RotorSport UK Ltd Service Bulletin (Permit)

Title: Cavalon 915is Lower engine cowling heat protection		Release date 10.10.2020
SB-138 Iss1	Related documents Modification: CCAR No.: None	Compliance Category: OPTIONAL or RECOMMENDED or MANDATORY
	Applicability	
Aircraft type & model: Cavalon 915IS	Aircraft serial Nos. affected: As required, optional	
The maintenance manual to be referenced is this stated or subsequent issue.		None
<p>This form is the response from RotorSport UK Ltd either against a problem found in the product in service requiring a containment or rectification action, or as service information for aircraft modification incorporation. For help, contact RotorSport on 44(0)1588 505060, or email compliance@rotorsport.org.</p> <p>The technical content of this document is approved under the authority of the UK CAA Design Organisation Approval Ref: DAI/9917/06</p>

Title: Cavalon 915 Lower Engine Cowling Heat Protection		
AG-SB-2020-05-B-EN		Compliance Category:
Applicability		A – MANDATORY B – RECOMMENDED C – OPTIONAL
Aircraft type & model: AutoGyro Cavalon	Affected Serial number(s): All Cavalon fitted with the Rotax 915iS engine	
The maintenance manual to be referenced

(Pic. 1)

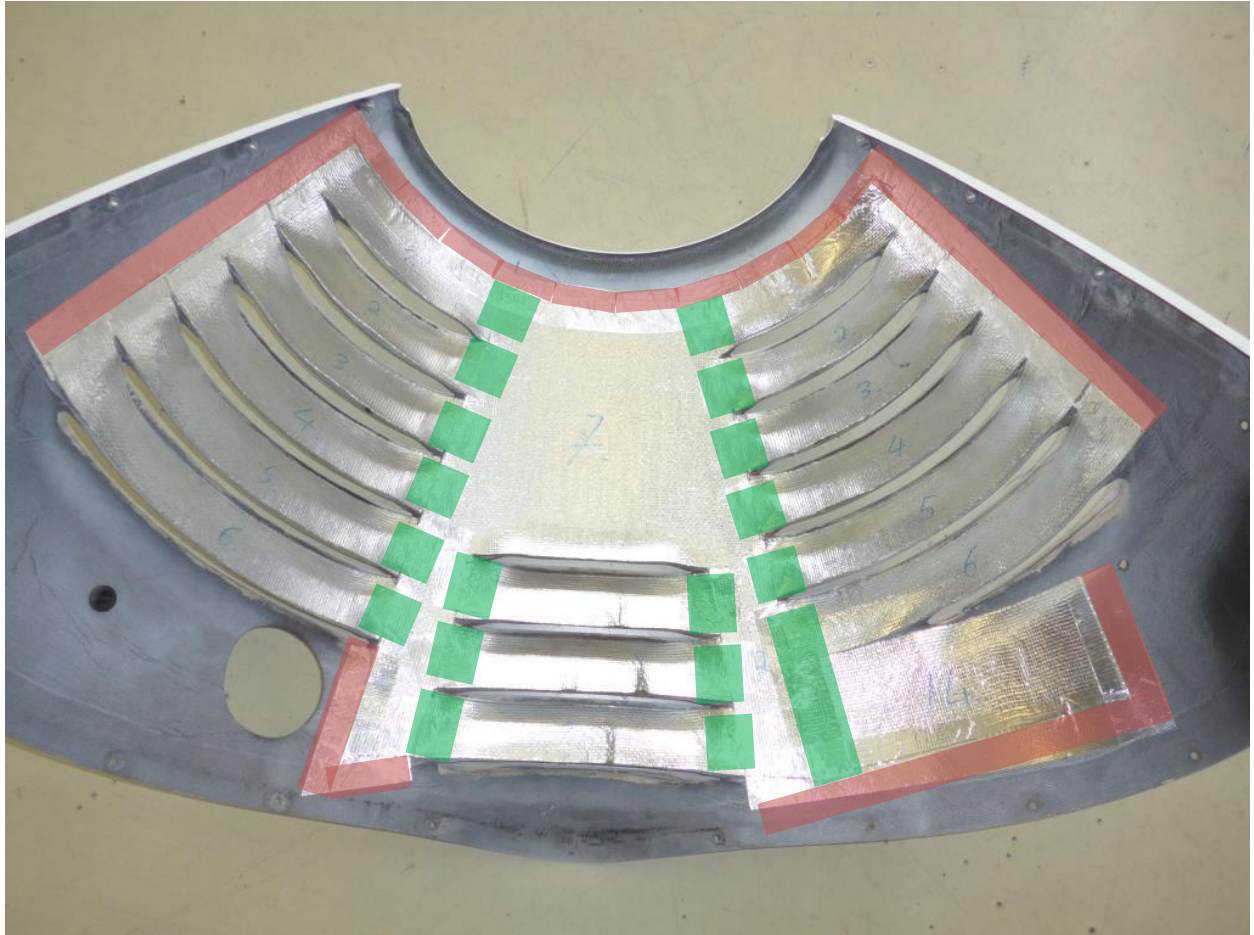
3. De-grease the inside area of the lower engine cowling in the areas where the heat protection is to be applied.
4. Attach the heat protection to the lower engine cowling using Pic. 1 below as a guide.

5. Using an appropriate medium, smooth the area of the interior surface of the cowling where the 50mm alu tape is to be applied (Pic. 2 red areas) and de-grease using silicone remover 34081 or similar. **If this is not carried out, it is extremely likely that the tape will detach from the cowling after a period of time.**

6. Apply the 50mm alu tape to the edges of the 50mm alu tape at both the previously smoothed areas (red areas) and the green areas shown in pic 2.
7. Re-fit the lower and upper engine cowlings.
